6.2 14/2015/MIN/A - 91-95 MONTAGUE STREET, SOUTH MELBOURNE

1. PURPOSE

- 1.1 To provide a Council position to the Minister for Planning C/- the Department of Environment, Land, Water and Planning to prepare, adopt and approve an Amendment to the Planning Scheme under Section 20(4) of the *Planning and Environment Act* for 91-95 Montague Street, South Melbourne.

Figure 3: Street wall height

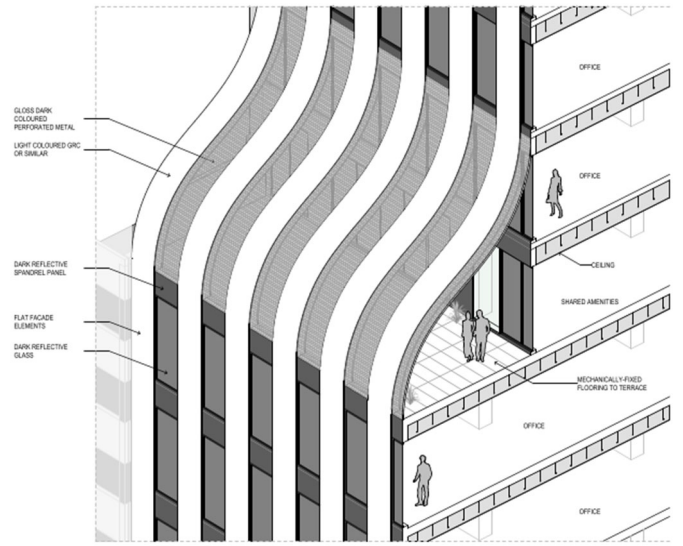
The proposed street wall and podium height read as taller than Gravity Tower because rather than stepping the tower back in a conventional manner with an unroofed podium rooftop above the street wall, the podium rooftop is enclosed by a 1.75m partly glazed balustrade and above this, is covered by a two-level volume convex curved perforated metal screen which continues the podium façade detailing in a rising curve to the top of Level 7 of the tower. This structure gives the building the appearance of having a six-level podium. This transition structure is repeated on the south-east side and Gladstone Place street frontage as well.

The proposed street wall would vary from the technical expectation for a 'stepped' height, including 4 storeys or less for 40 percent of the frontage as required by DD030. It is recommended the point where the front façade starts to splay back to the tower be reduced by at least one storey. The recommended design response would assist the street wall to read as commencing at Level 5 and provide a human scale to the street wall.

Whilst the street wall height is one storey less than the maximum street wall height, the architectural design response of the building needs to have due regard to its site context and street rhythm, noting that the floor to floor heights of plant and commercial uses are greater than the heights of the corresponding car parking and residential levels within the podium of Gravity Tower.

It is considered that combined with an overall reduction in the building height by to be no higher than 22 levels, have a maximum roof height of 87.03m AHD, have a maximum plant height of 88.91m AHD and increase the tower setbacks from Montague Street and Gladstone Place to be no less than Gravity Tower, the proportions and architectural expression of the building would provide an improved response to the DDO30 character precinct objectives and improved pedestrian scale along a key arterial route within the precinct.

Figure 5: Montague Street building heights

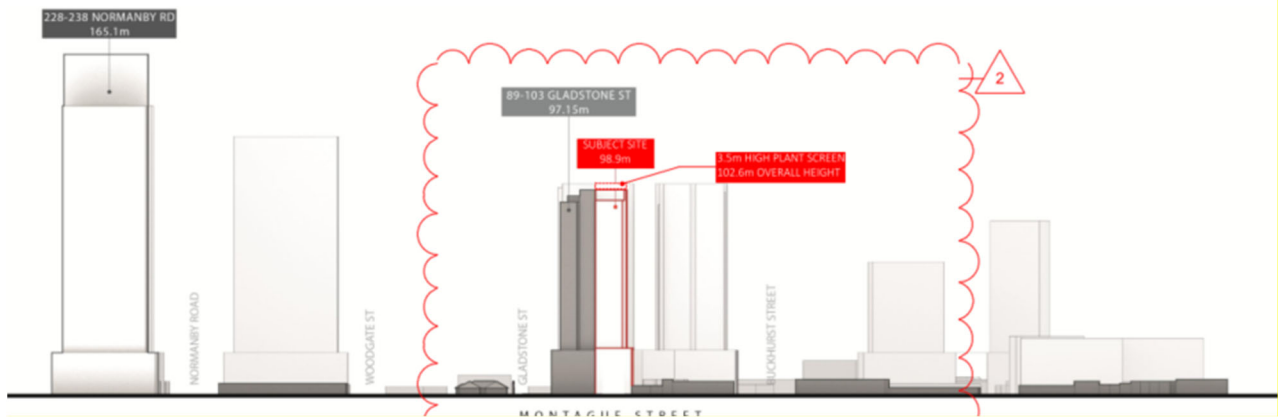
The proposal would not contribute to a "*varied and architecturally interesting skyline*". As illustrated in the Design Response provided by the project architect (see Figures 4 and 5) the proposed building height appears to be more a continuation of the heights achieved by existing and approved buildings in the block bounded by Montague, Gladstone, Kerr and Buckhurst Streets.

Note: The approval for the building shown at 228-238 Normanby Road lapsed on 20-05-2019. There is no planning approval for this site.

Figure 6: Buckhurst Street Building heights.

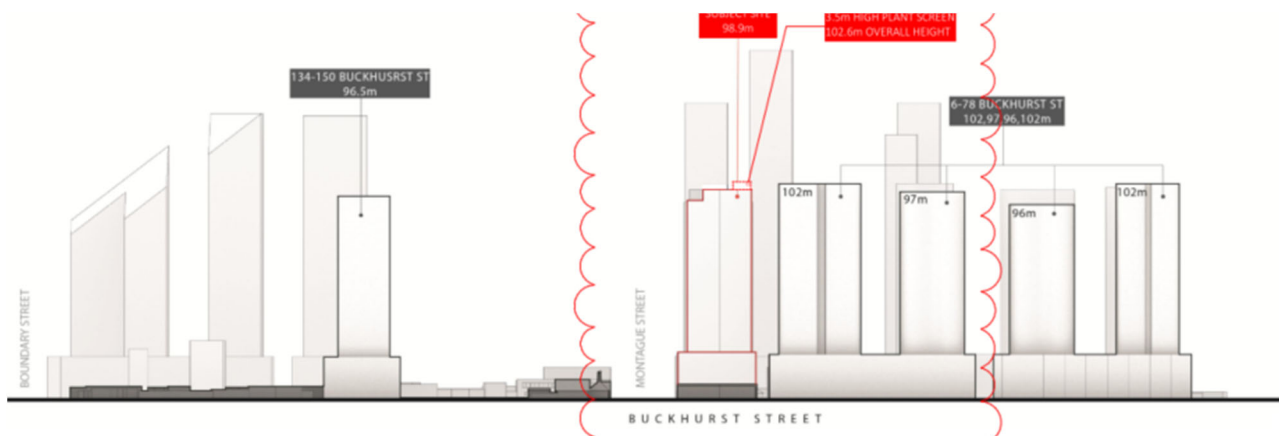
Note 1: The approval for the building shown at 134-150 Buckhurst Street lapsed on 01-09-2019. There is no planning approval for this site.
